**TOWN OF NEWBURGH
PLANNING BOARD
TECHNICAL REVIEW COMMENTS**

PROJECT: WEBB PROPERTIES
PROJECT NO.: 14-10
PROJECT LOCATION: SECTION 97, BLOCK 2, LOTS 13.22, 35 & 43
PROJECT REPRESENTATIVE: A. DIACHISHIN & ASSOCIATES
REVIEW DATE: 26 NOVEMBER 2014
MEETING DATE: 4 DECEMBER 2014

Re: Site Plan for Webb Properties, Inc., Town of
Newburgh Planning Board **Project Number 2014-10.**

NARRATIVE

Landscaping, Signage, Lot Coverage Calculations Site Plan for Webb Properties, Inc.

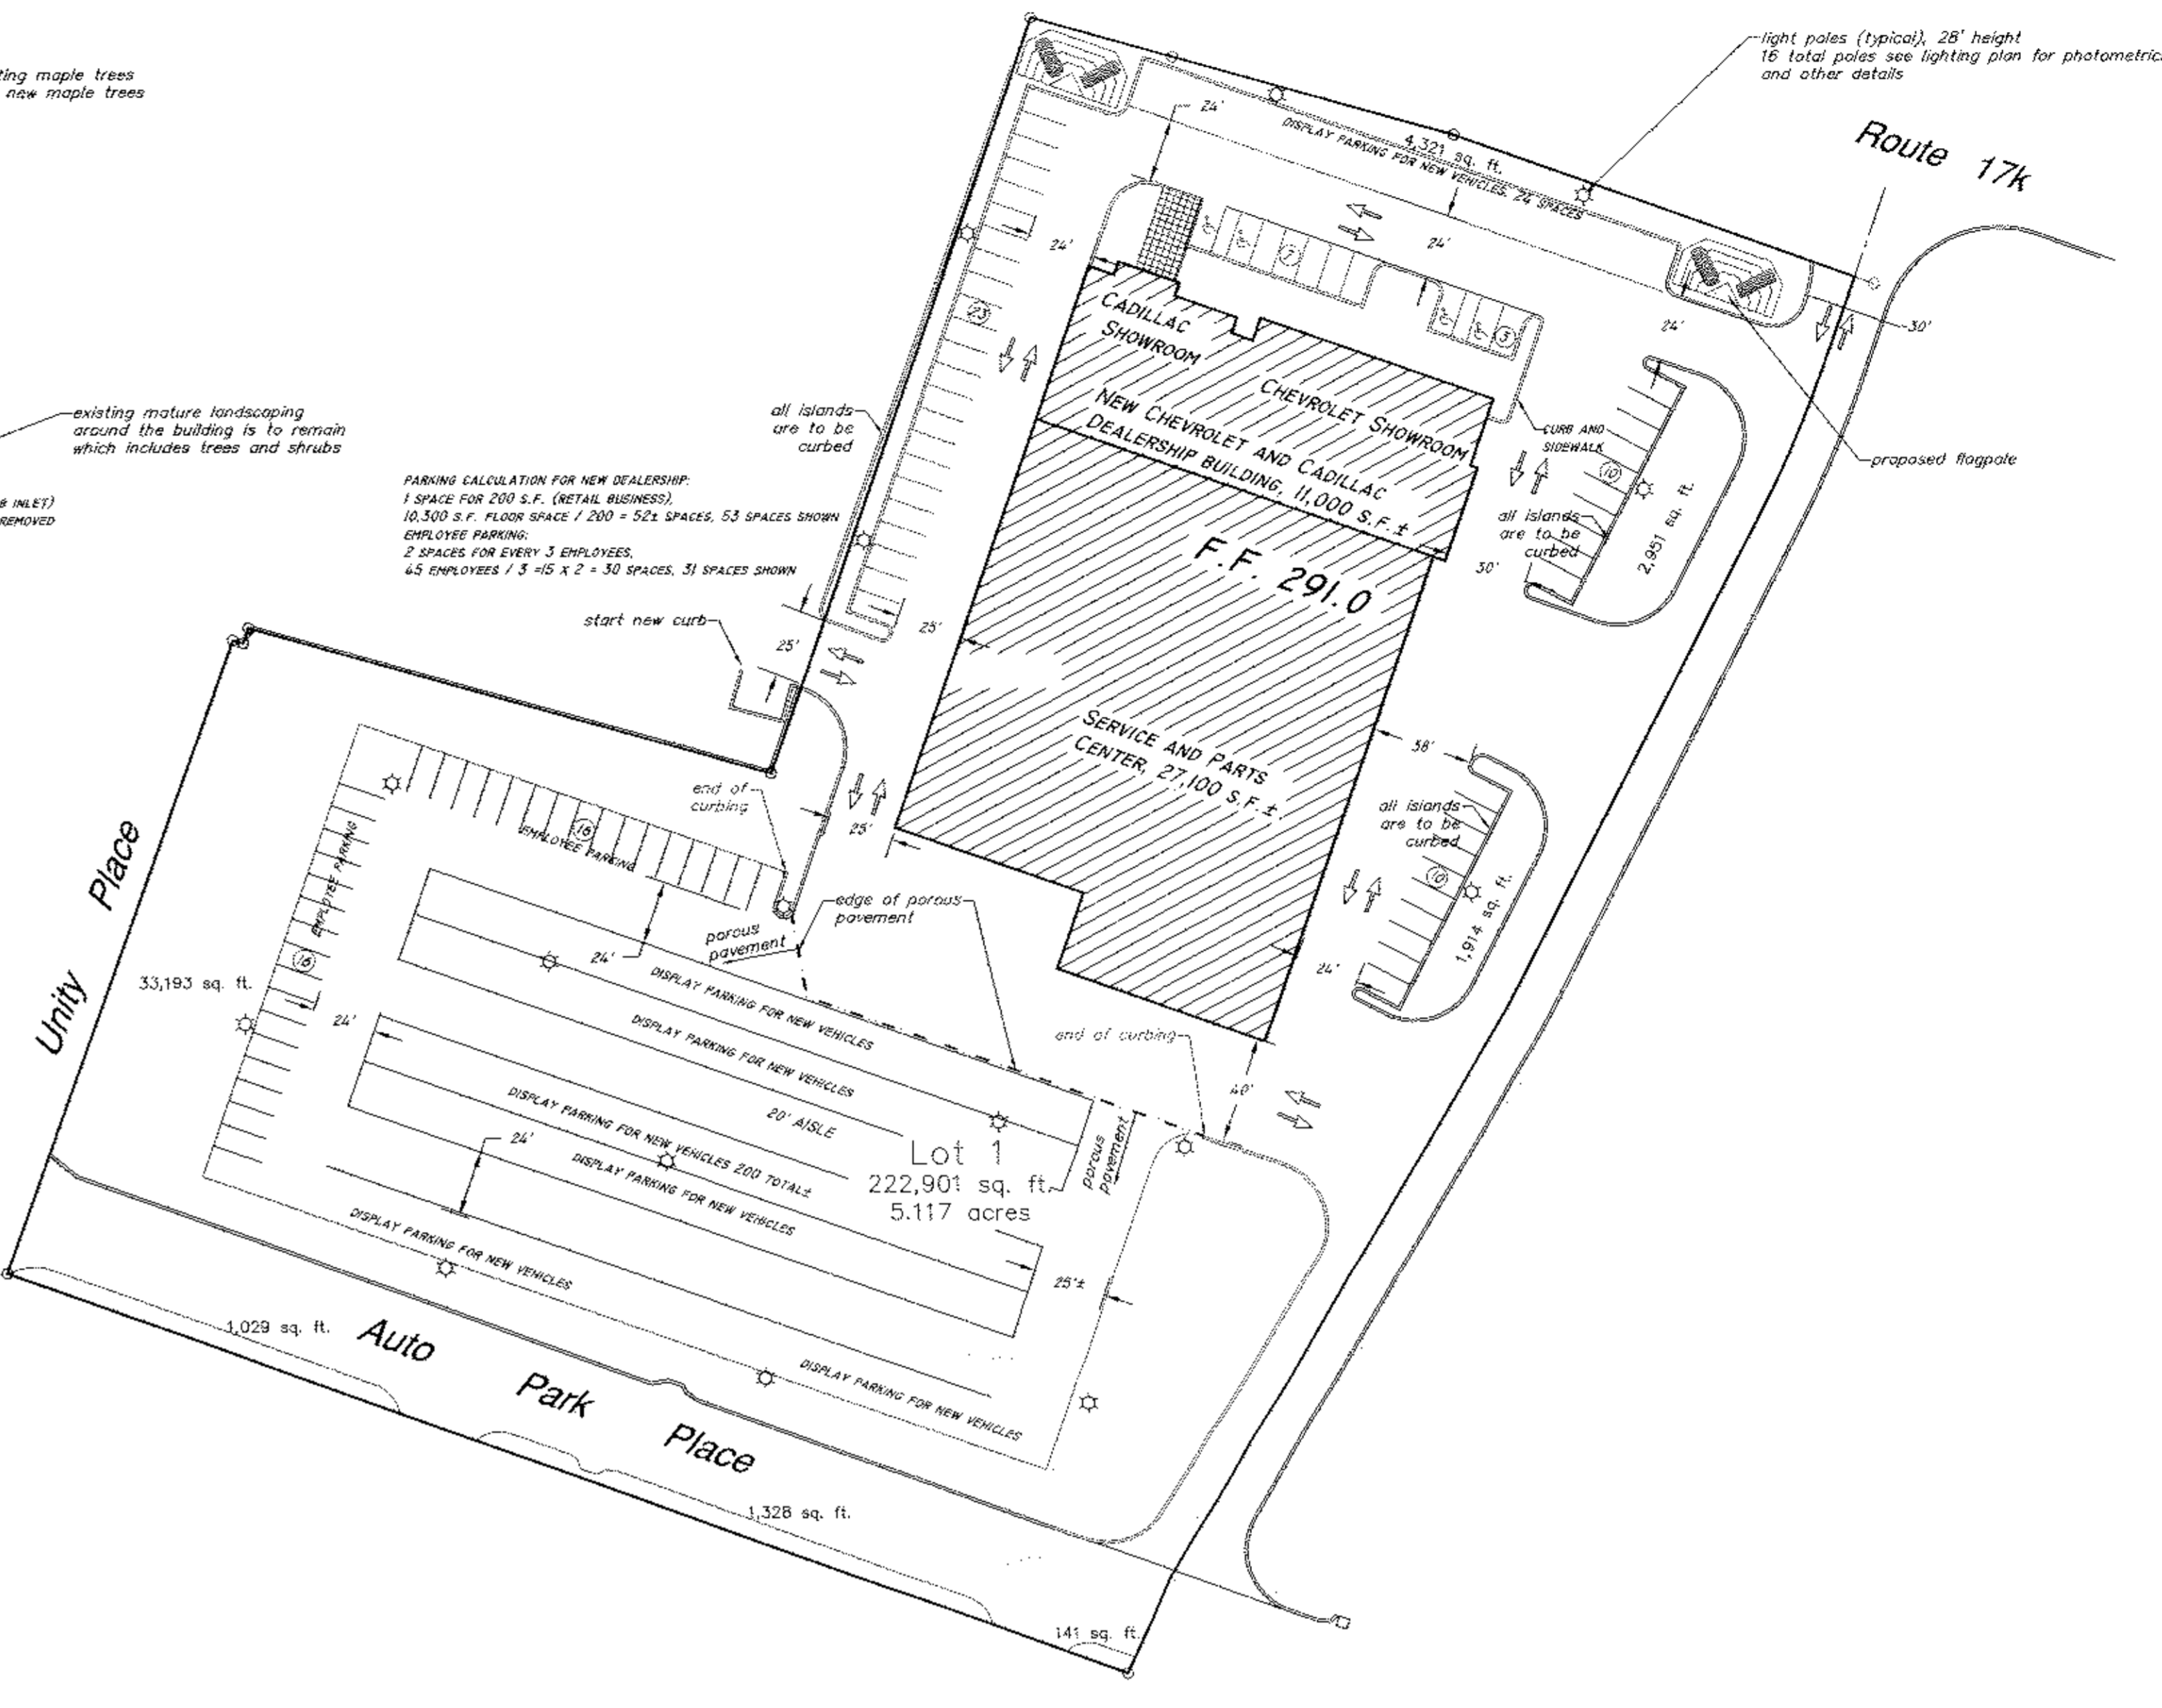
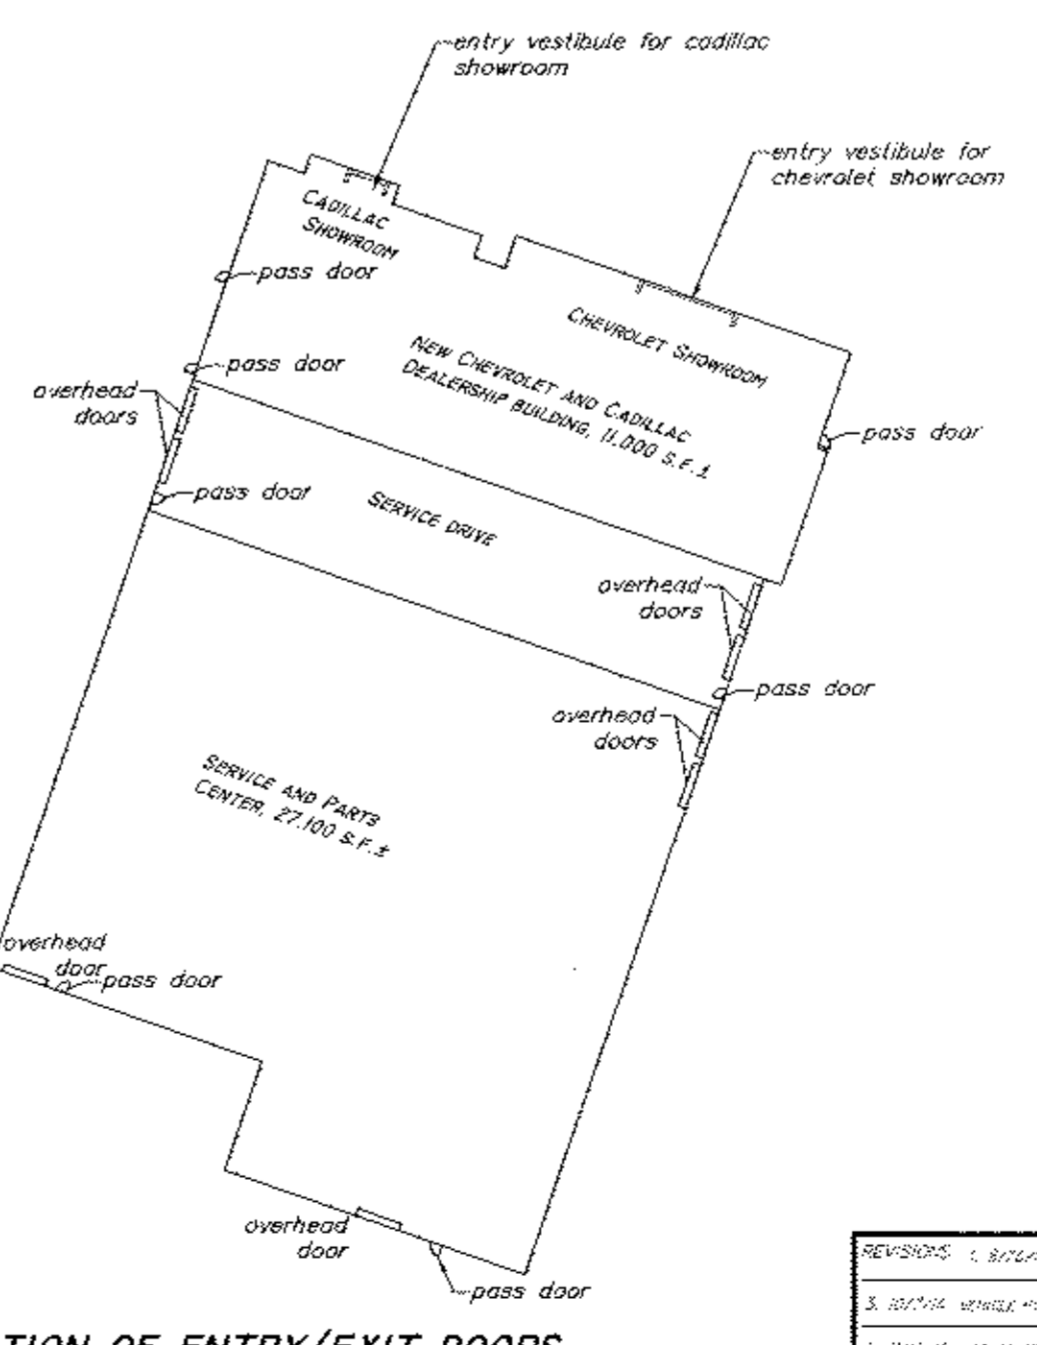
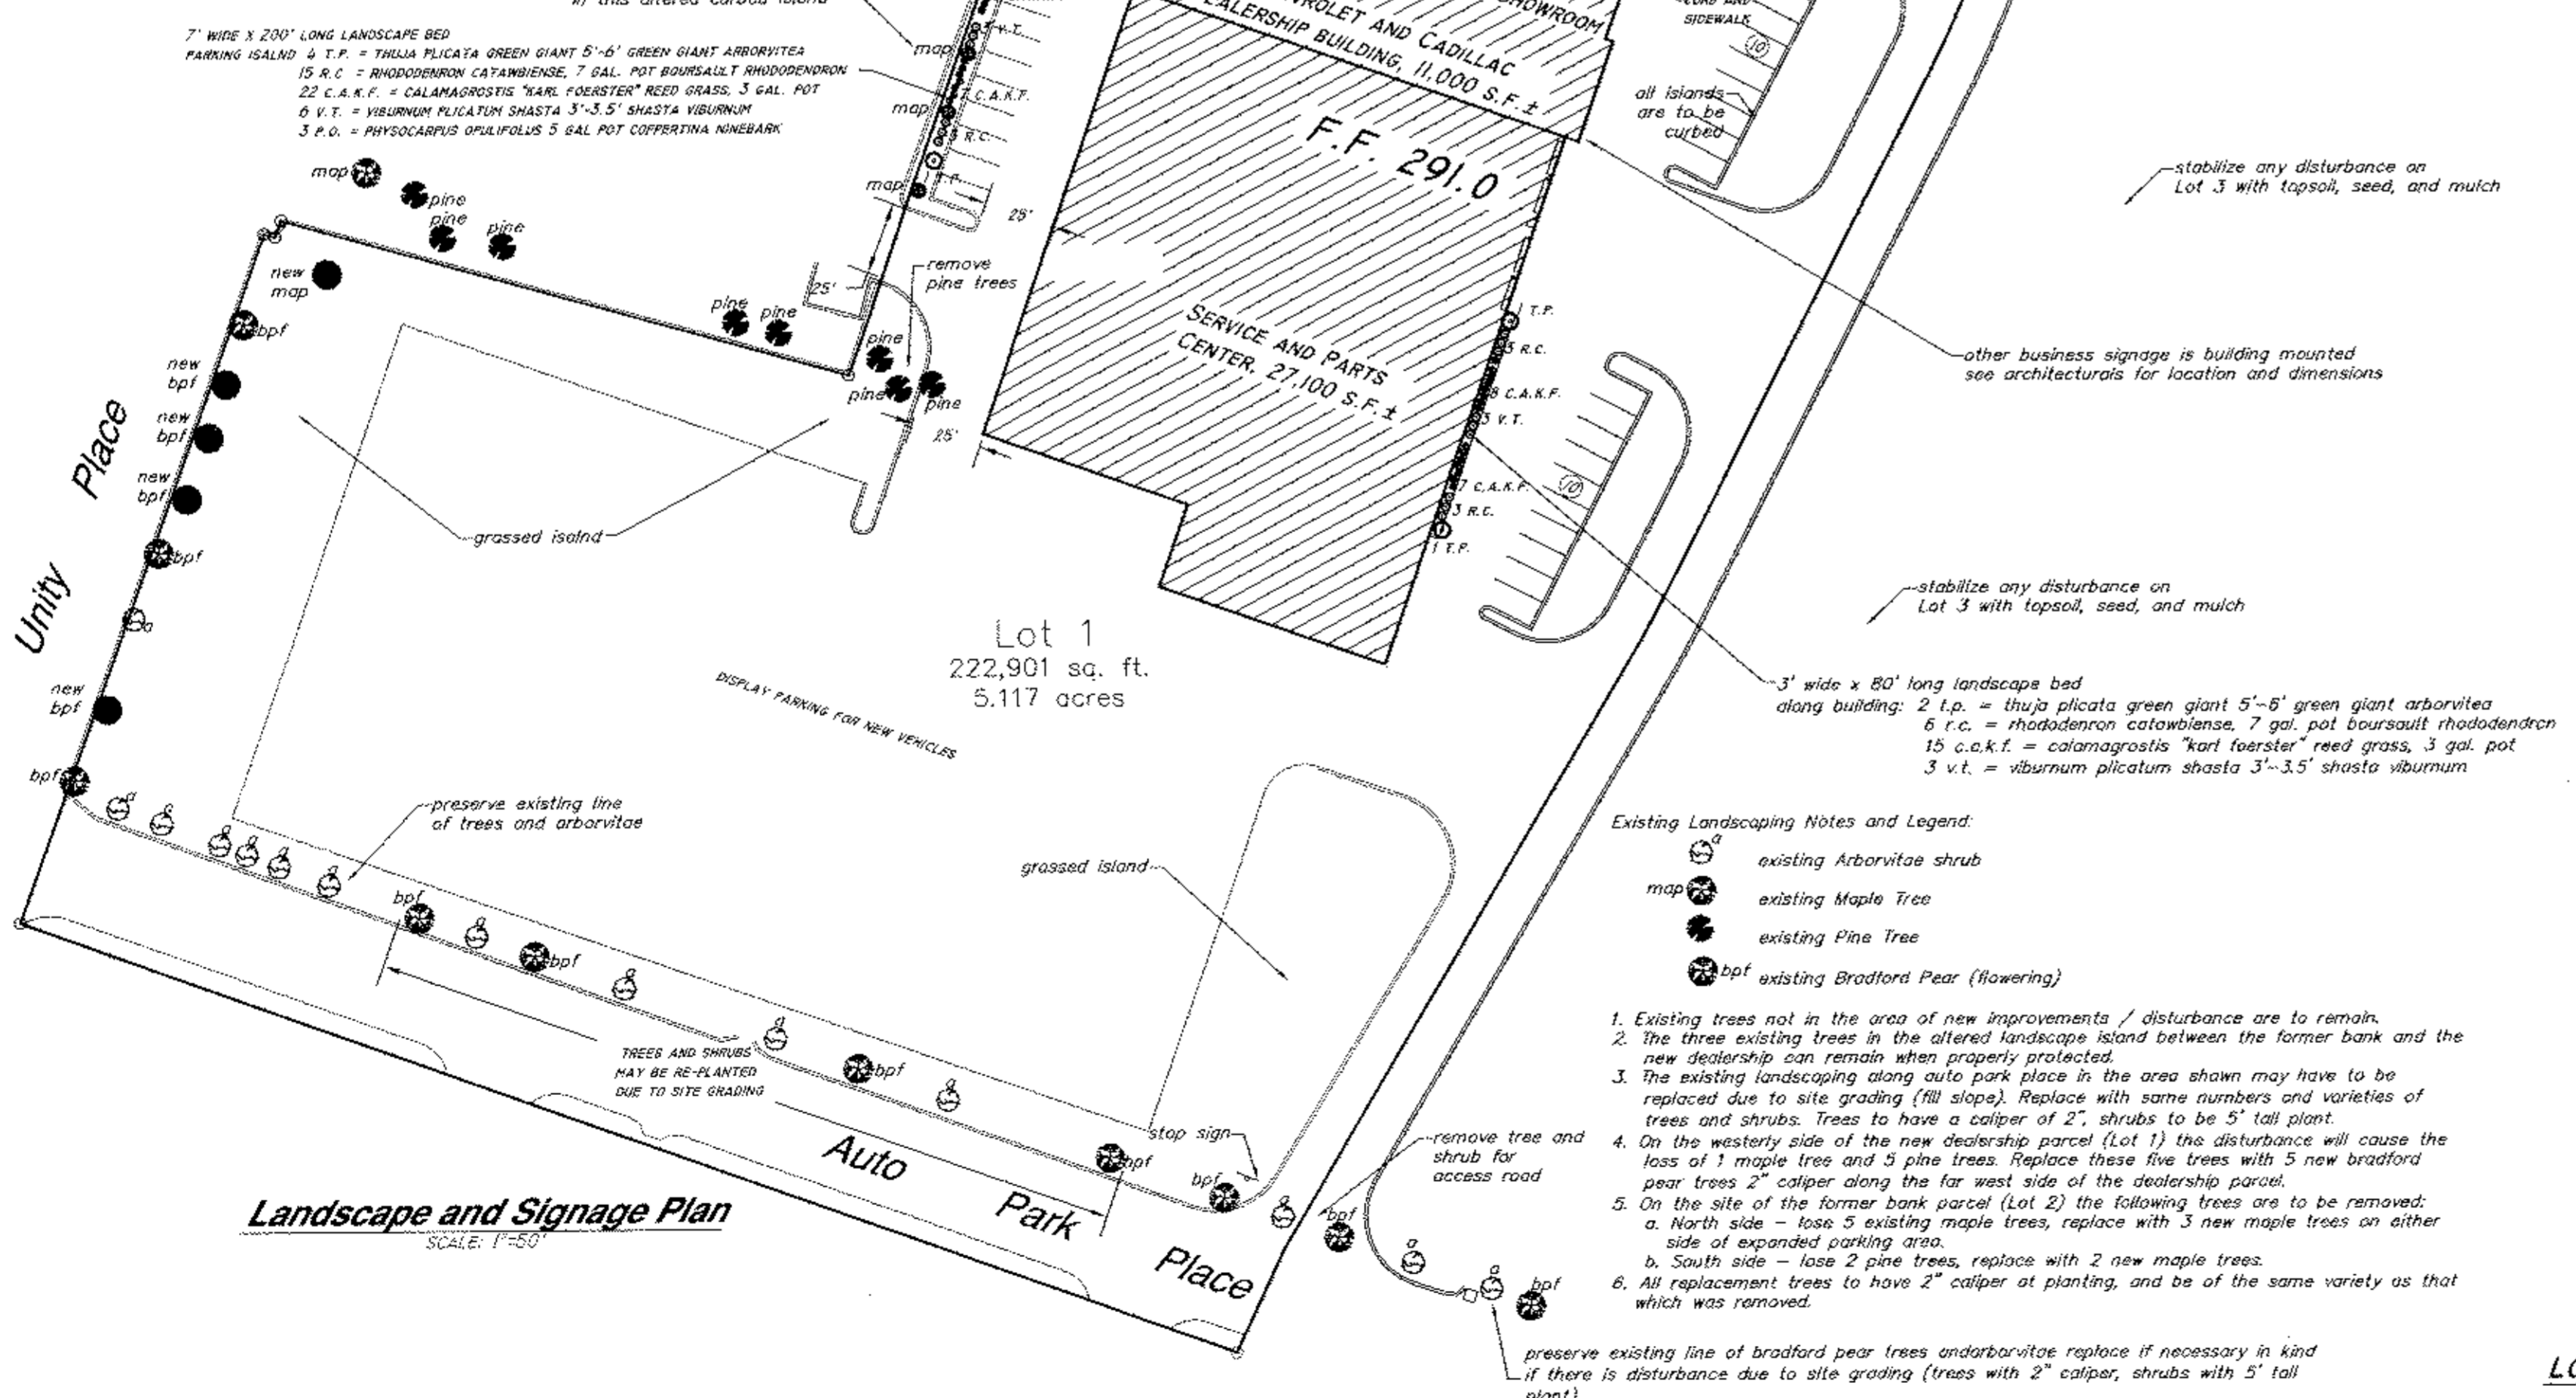
1. Plan sheets should be coordinated throughout the plan set, example being Infiltration Basin Area is depicted as grassed island in other sheets.
2. Site landscaping plans must be developed in accordance with Town of Newburgh design standards and zoning code. Landscaping of infiltration basins, internal islands, and site perimeter should be developed consistent with other projects within the Town and in conformance with design guidelines.

5. & 12. Existing and proposed landscaping has been addressed on the former bank parcel. Any disturbance on Lot 3 to the east will be re-vegetated with grass. Soil restoration practices have been added.

- Existing Landscaping Notes and Legend:**
- existing Arborvitae shrub
 - existing Maple Tree
 - existing Pine Tree
 - existing Bradford Pear (flowering)
1. Existing trees not in the area of new improvements / disturbance are to remain.

2. The three existing trees in the altered landscape island between the former bank and the new dealership can remain when properly protected.
 3. The existing landscaping along auto park place in the area shown may have to be replaced due to site grading (fill slope). Replace with same numbers and varieties of trees and shrubs. Trees to have a caliper of 2", shrubs to be 5' tall plant.

4. On the westerly side of the new dealership parcel (Lot 1) the disturbance will cause the loss of 1 maple tree and 3 pine trees. Replace these five trees with 5 new Bradford pear trees 2" caliper along the far west side of the dealership parcel.

5. On the site of the former bank parcel (Lot 2) the following trees are to be removed:
 - a. North side - lose 5 existing maple trees, replace with 3 new maple trees on either side of expanded parking area.

- b. South side - lose 2 pine trees, replace with 2 new maple trees.
 6. All replacement trees to have 2" caliper at planting, and be of the same variety as that which was removed.
